Grid-Connected PV Systems Design and Installation

Revisions to the Grid-Connected PV Systems: Design and
Installation Australian Edition Version 8.8 Publication

Following is the summary of changes to the information within Grid-Connected PV Systems Design and Installation Australian Edition Version 8.8, December 2020. Please note that the changes in this document are subject to alterations in newer editions. While all care has been taken to ensure this document is free from omission and error, no responsibility can be taken for the use of this information in the design or installation of any grid-connected PV system.

Figure 14.2: a) PV string cable with minimised inductive loop area. b) PV string cable that has an inductive loop. This should be avoided.

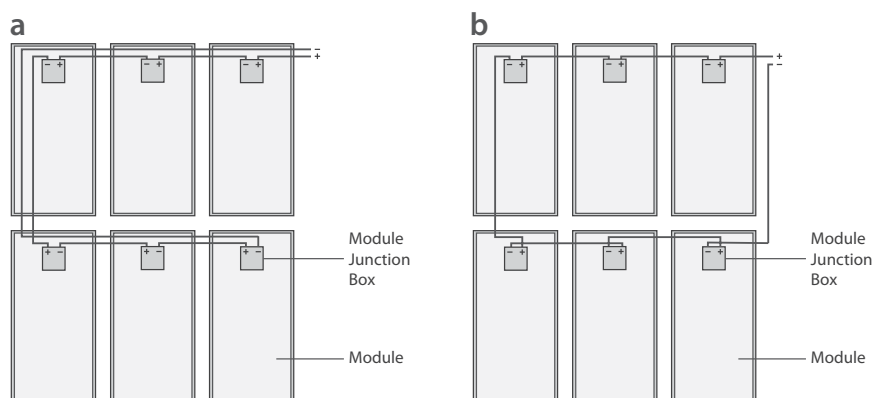
3. Section 14.1.3 - Cable Routes and Length

Replacement of Figure 14.2:
